MTM GARMENTS LTD.

15934/16004 Chandpara, Medical Road, Uttarkhan
(23.877554N,90.434111E)

4th November 2015

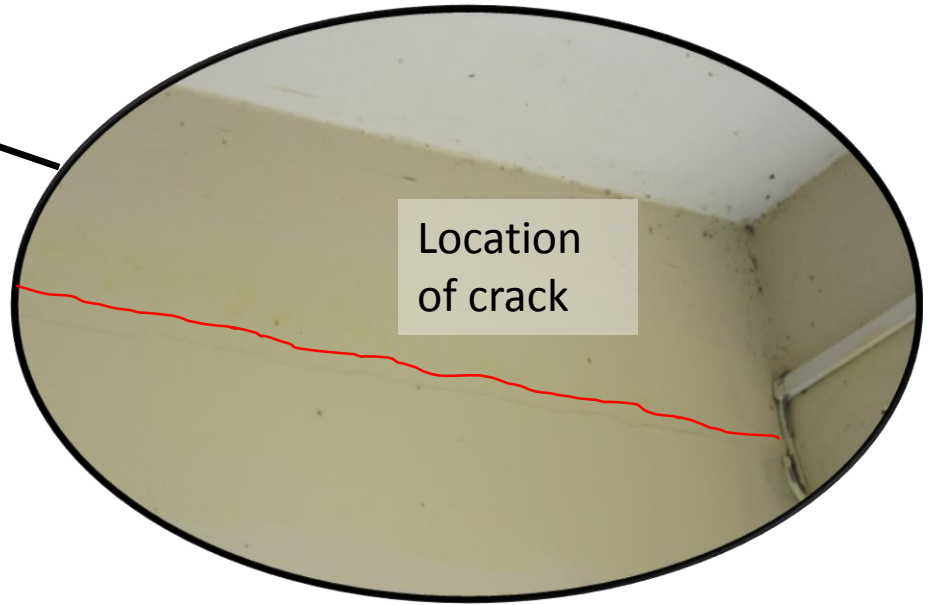
Holes drilled into purlins and hangers welded on

Hangers hooked on purlin lateral restraints
